Opal St Clair

Response to letter 19th November 2021

17th June 2022

Southern and Central Wings View 5 and 6

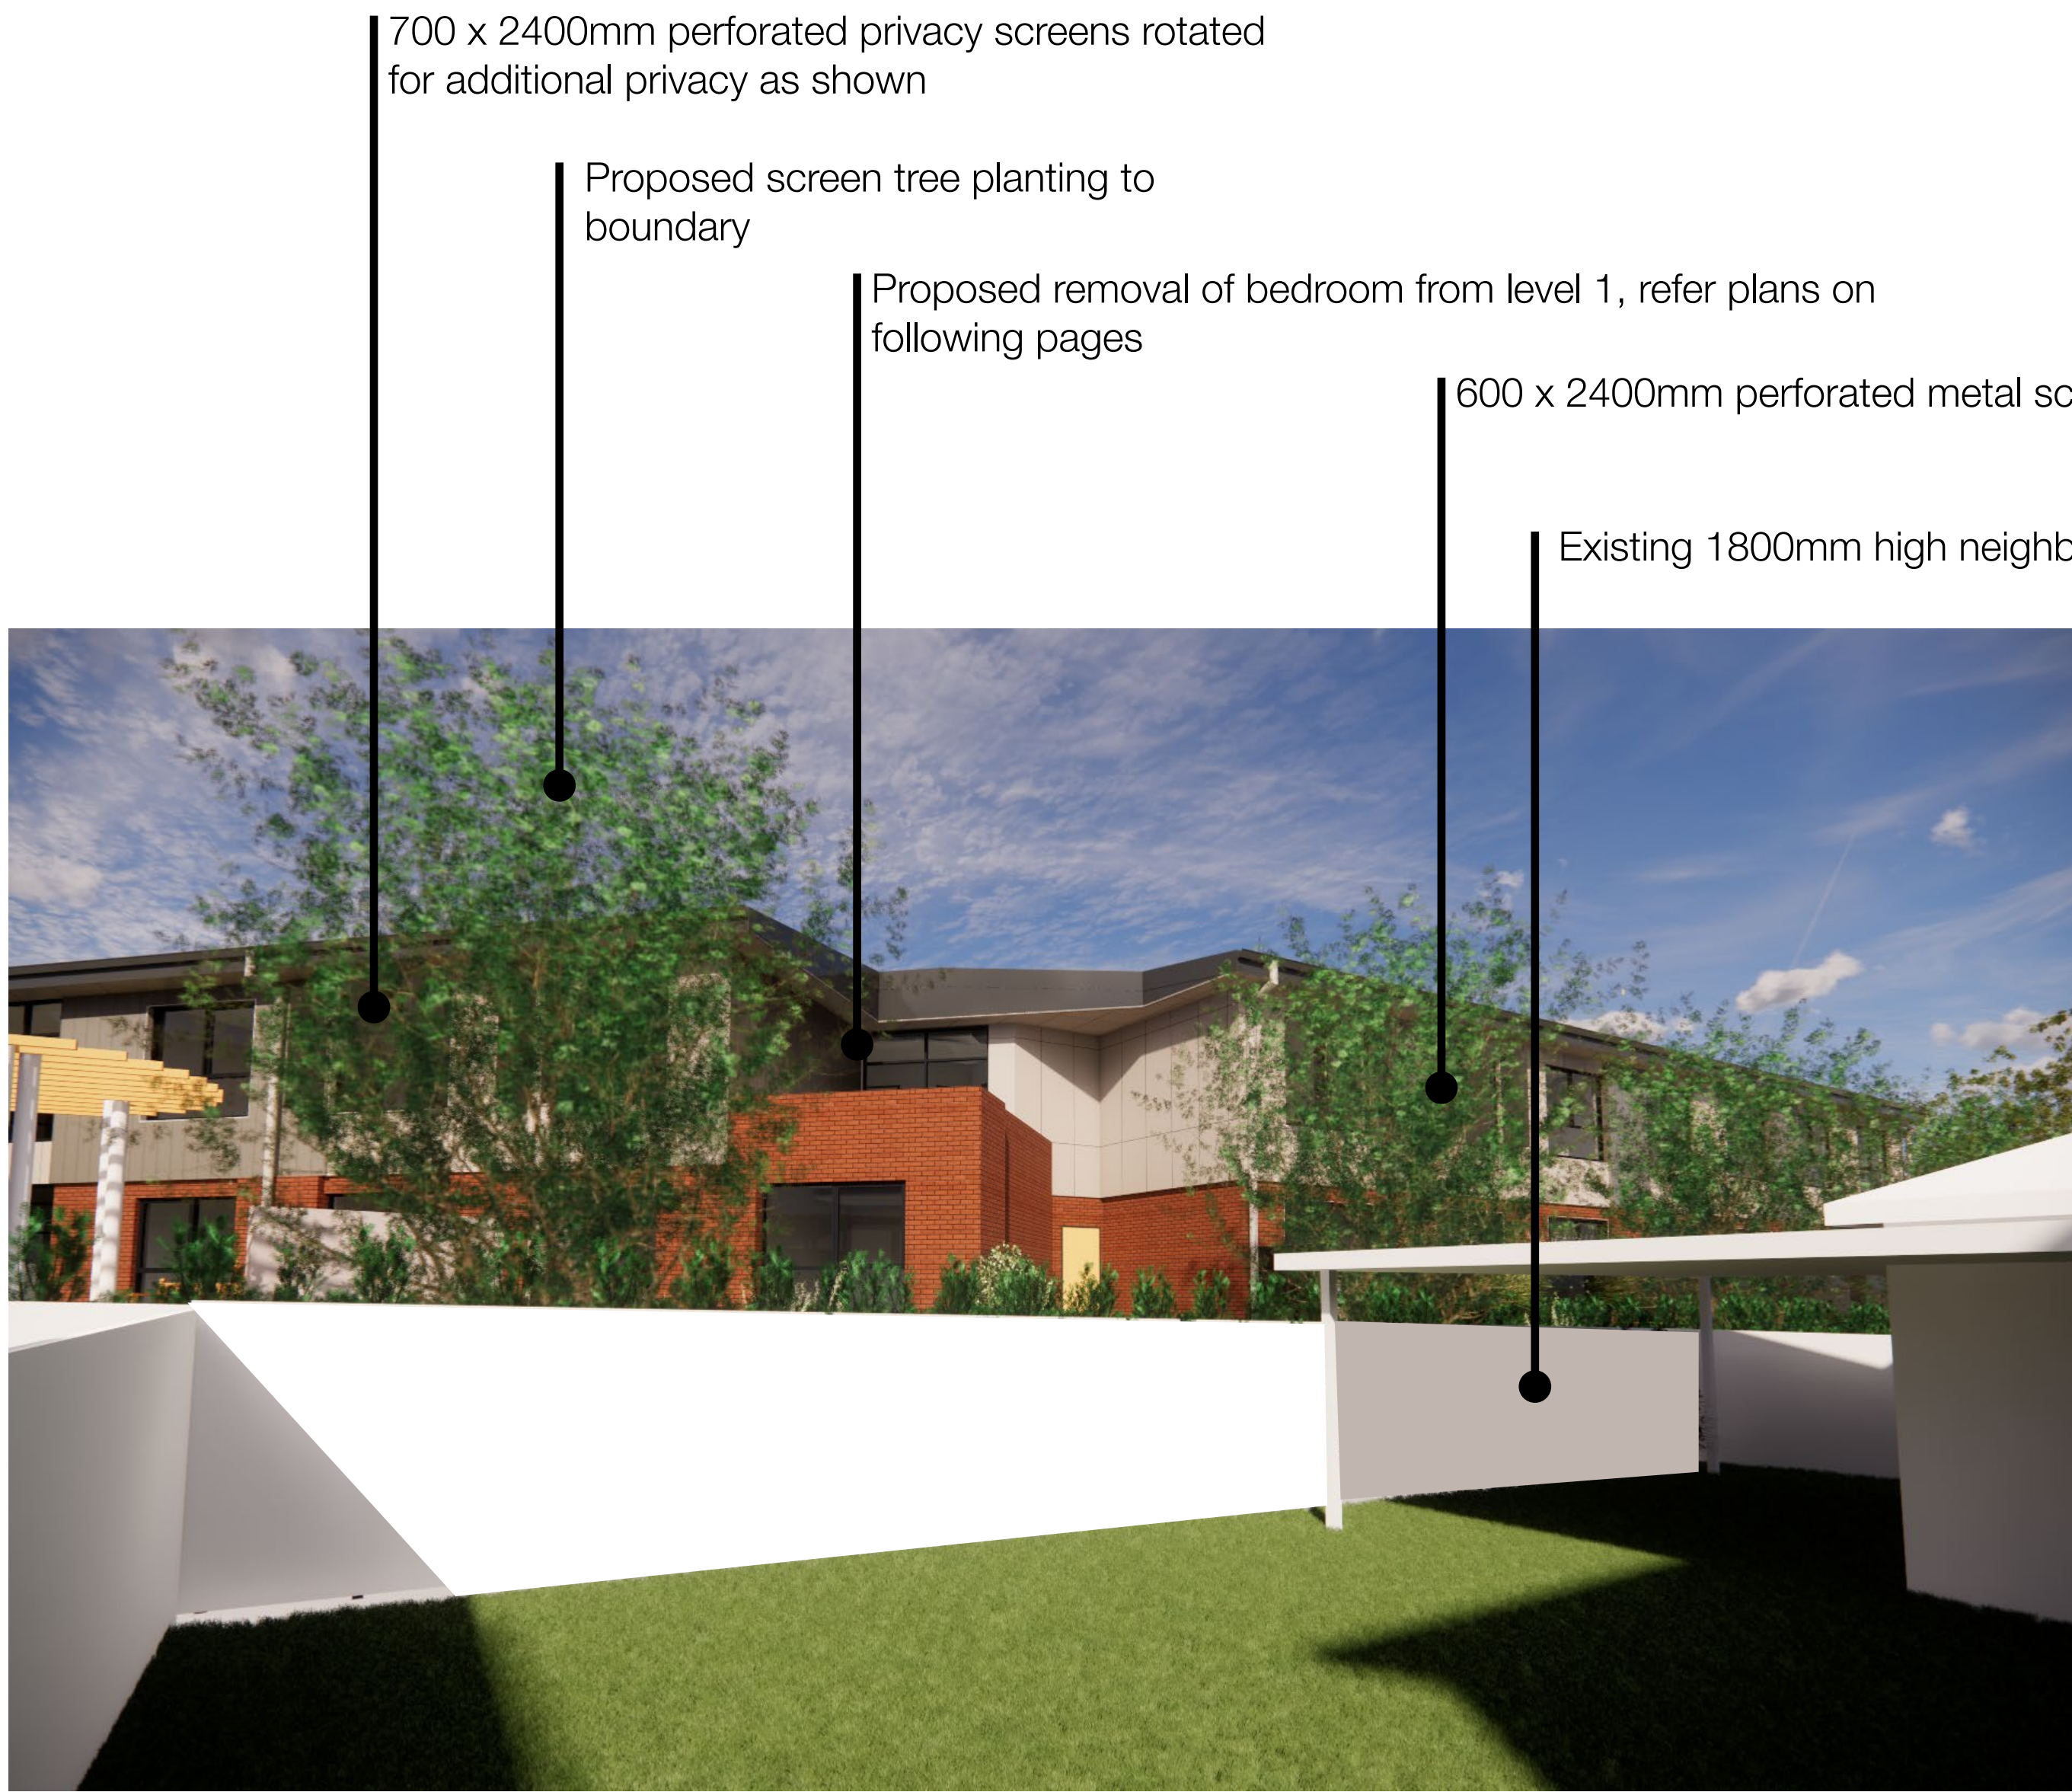
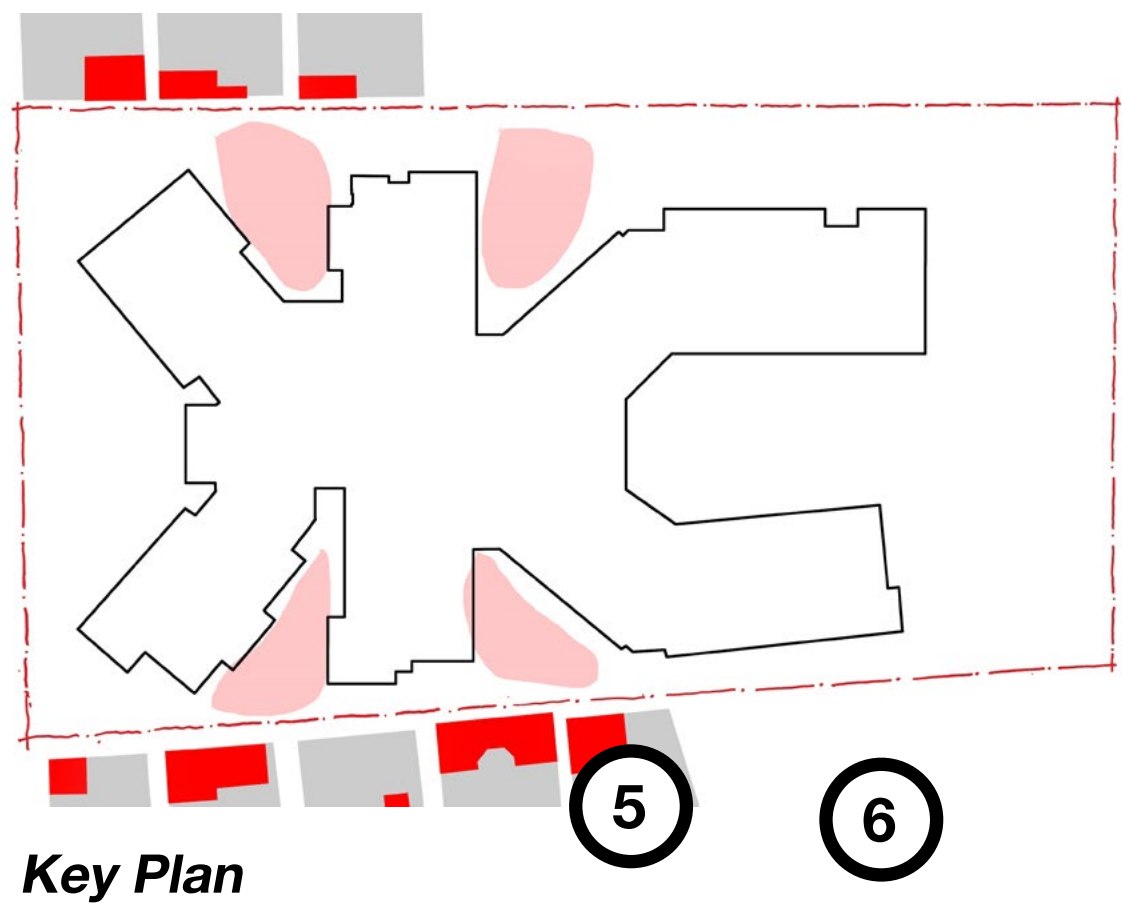
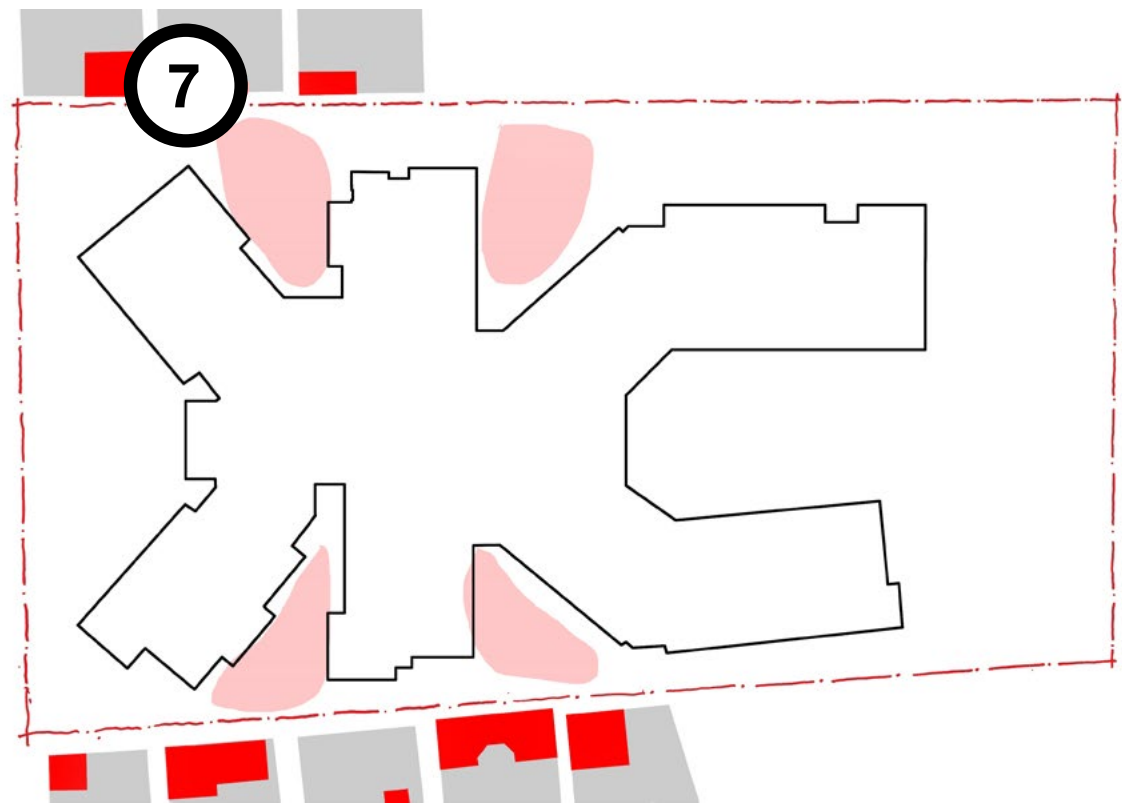
Concern is raised regarding the overall bulk of the building, including the extension of the front and central building wings to within close proximity of the side boundaries, the extension of the north eastern wing to within close proximity of the eastern side boundary, and the provision of ground floor levels which are significantly above the existing ground levels (i.e. up to approximately 2.5m above in the north eastern corner of the development). It is noted that Council's Urban Design Review Panel have reviewed the proposal and have raised issue in relation to the insufficient vertical expression, apparent building length and overall building bulk

The proposed facade treatment adjoining neighbouring dwellings is highly articulated with residential scale particularly in relation to the southern and central wings. A number of views from neighbouring properties have been prepared to illustrate this when viewed from the POS of adjoining properties (shown in red).

Further to the above, modifications are proposed to the building mass through the removal of first floor bedrooms amongst other internal changes. These improvements are reflected in the updated views and the proposed plans reflected on pages on 10 and 11
